**Anchor QEA Memorandum  
“Response to U.S. Army Corp of Engineers’ Request  
for Additional Information”**

**To:** Erin Legge, U.S. Army Corps of Engineers      **Date:** March 28, 2013  
**From:** Heather Griffin, City of Everett  
Heather Page, Anchor QEA, LLC  
**Re:** Kimberly Clark DWO Project (NWS-2000-34)  
Response to U.S. Army Corps of Engineers' Request for Additional Information

**PLANTING PLAN**

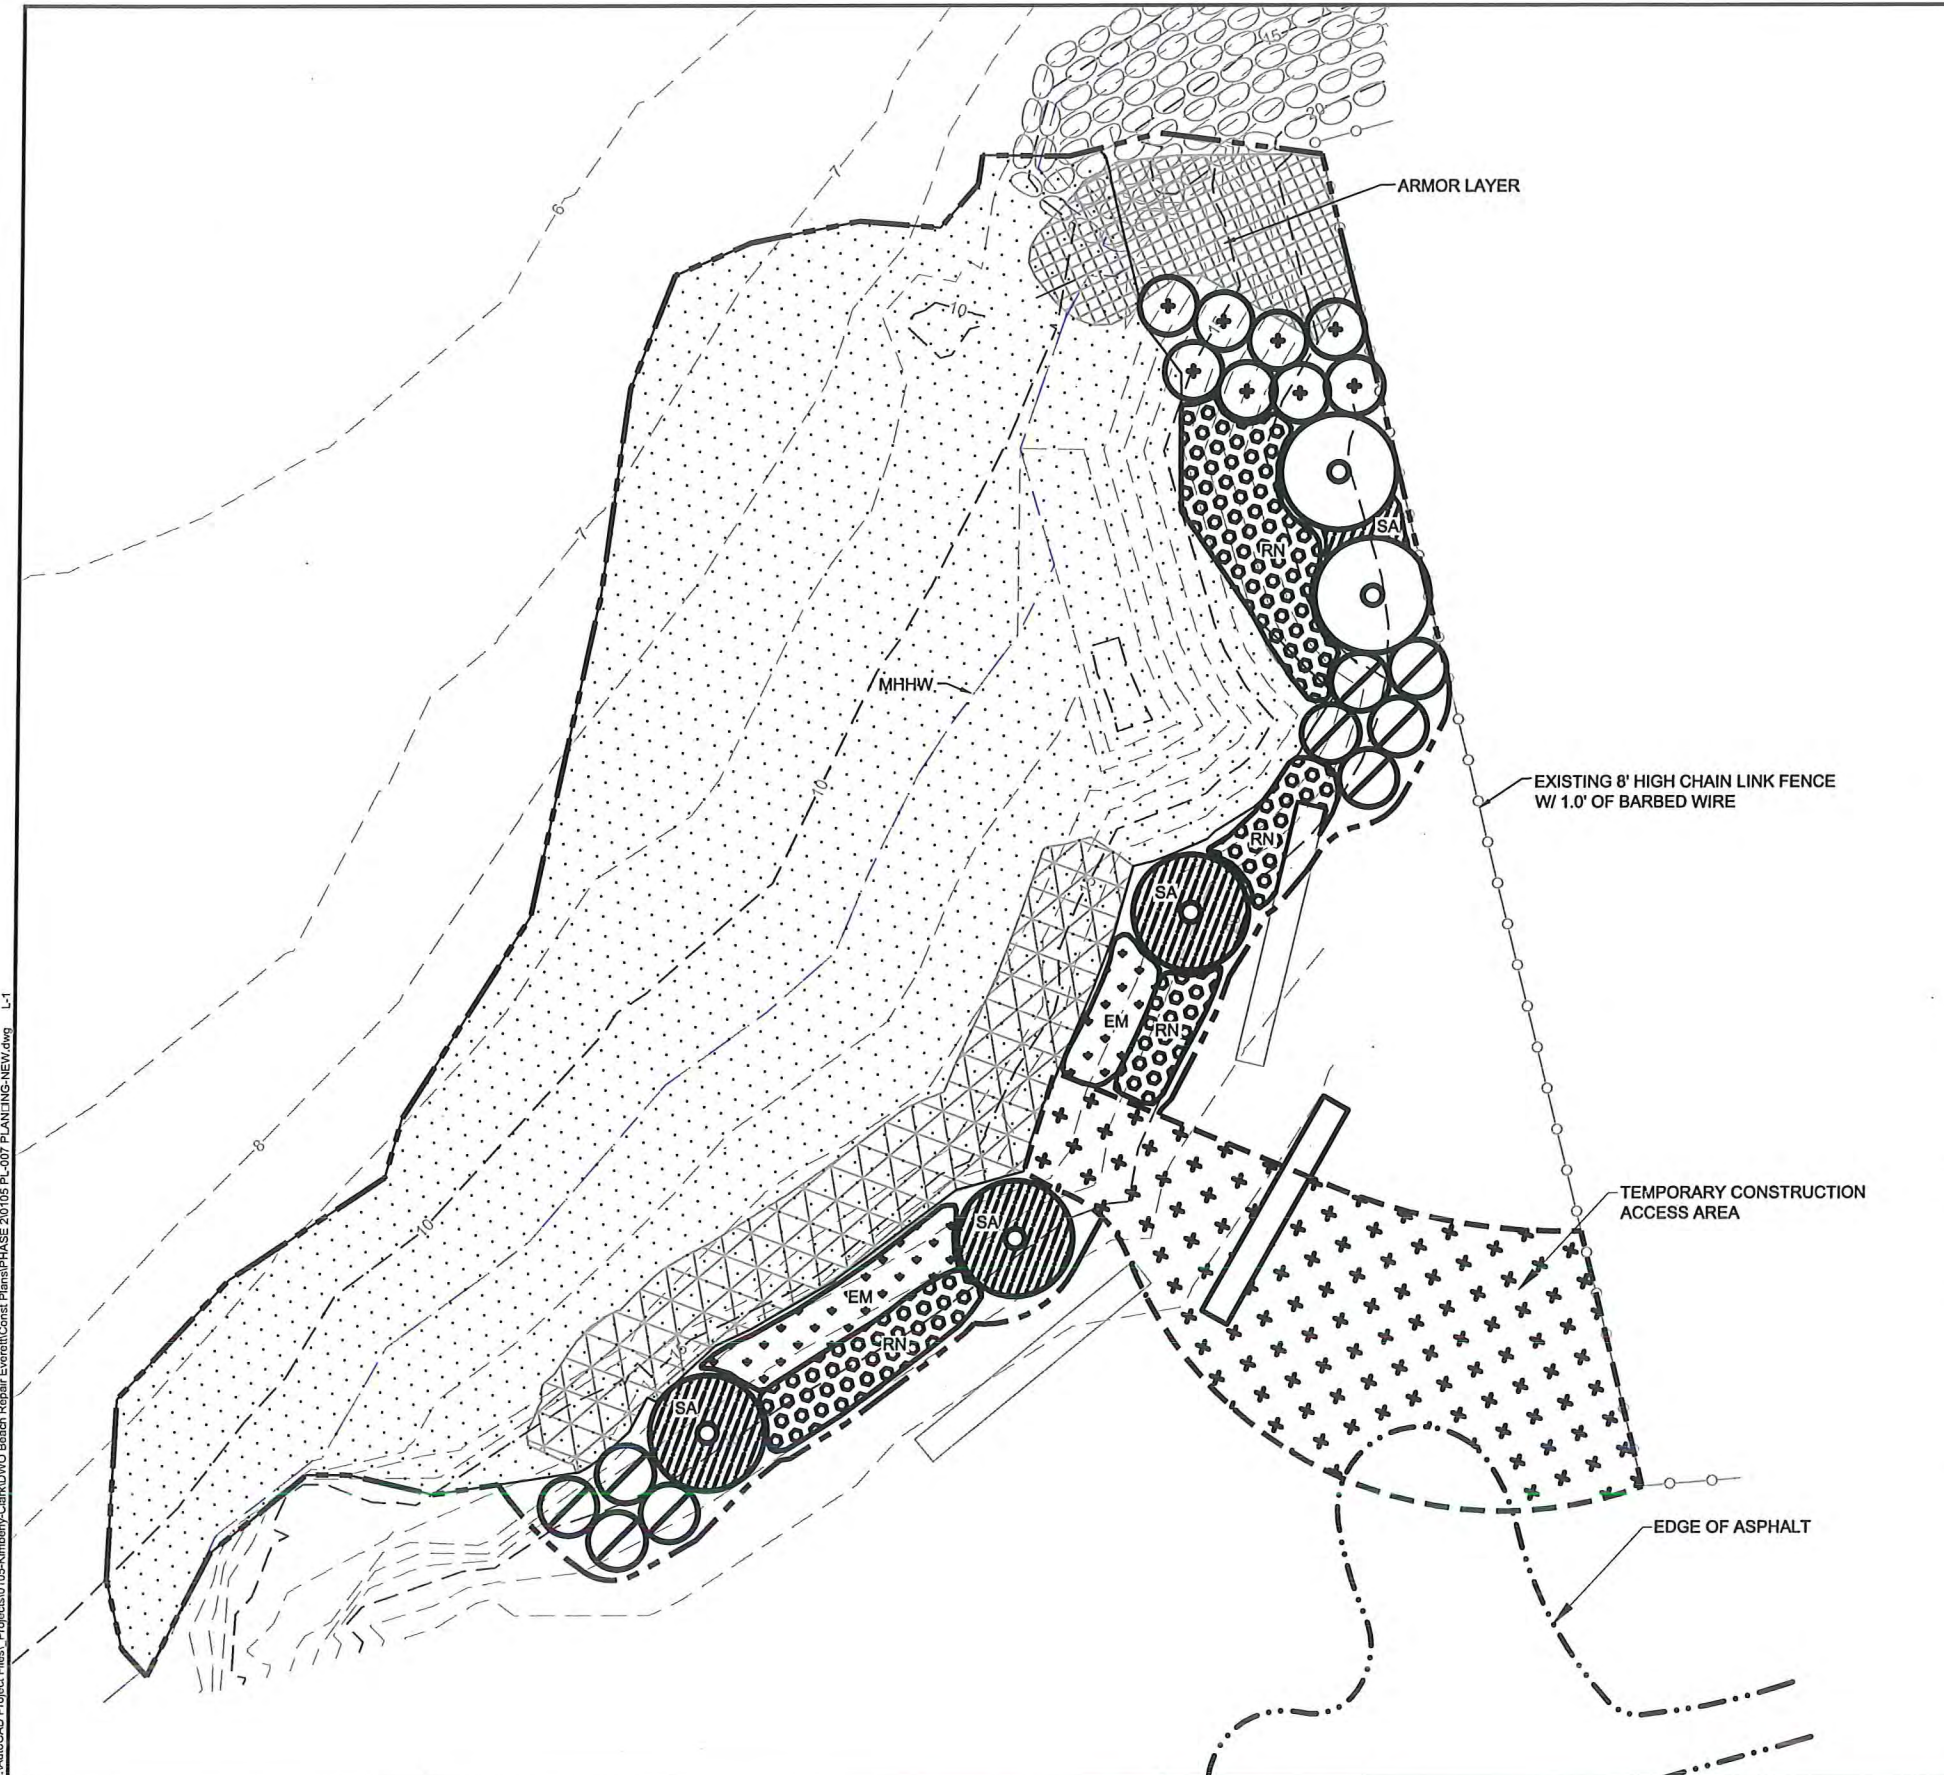
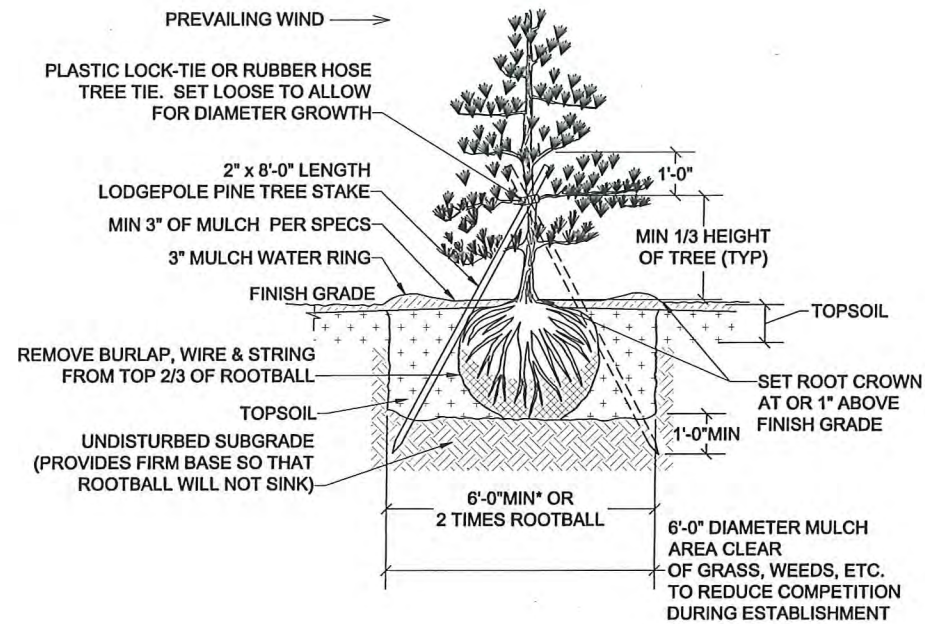
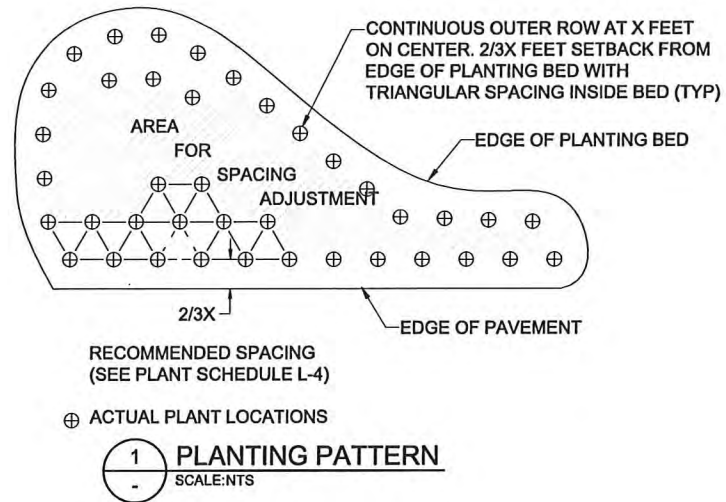
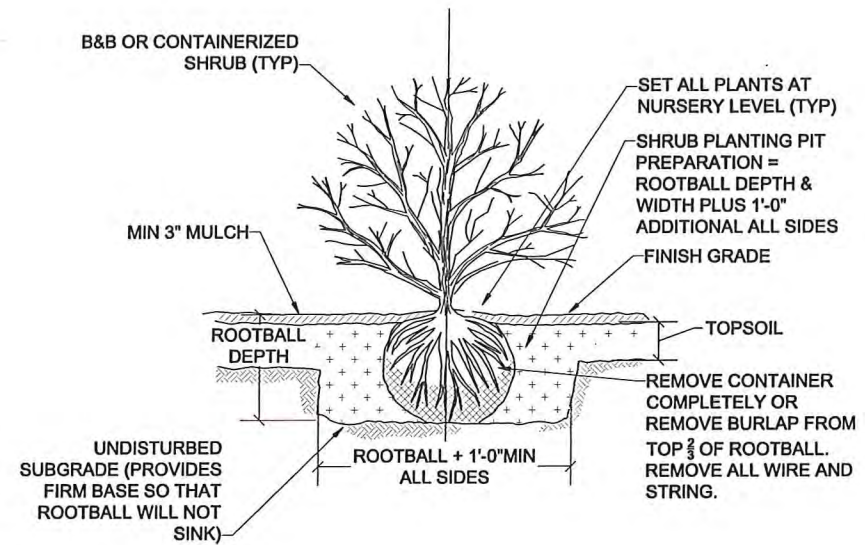
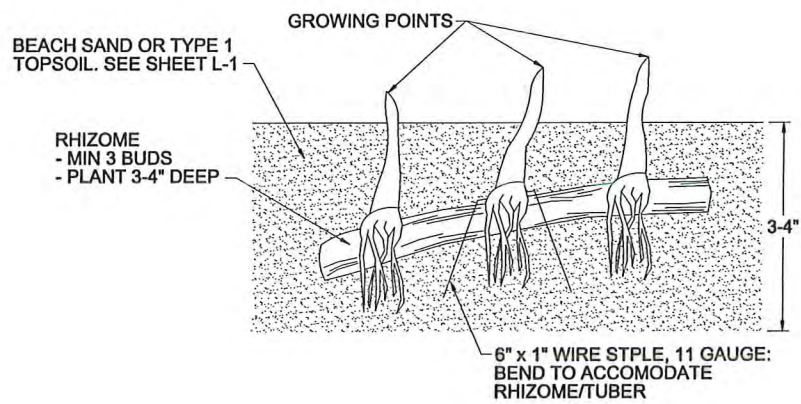
**Planting plan using native riparian plant species**

Please see Attachment 3 the planting plan proposed for the project.
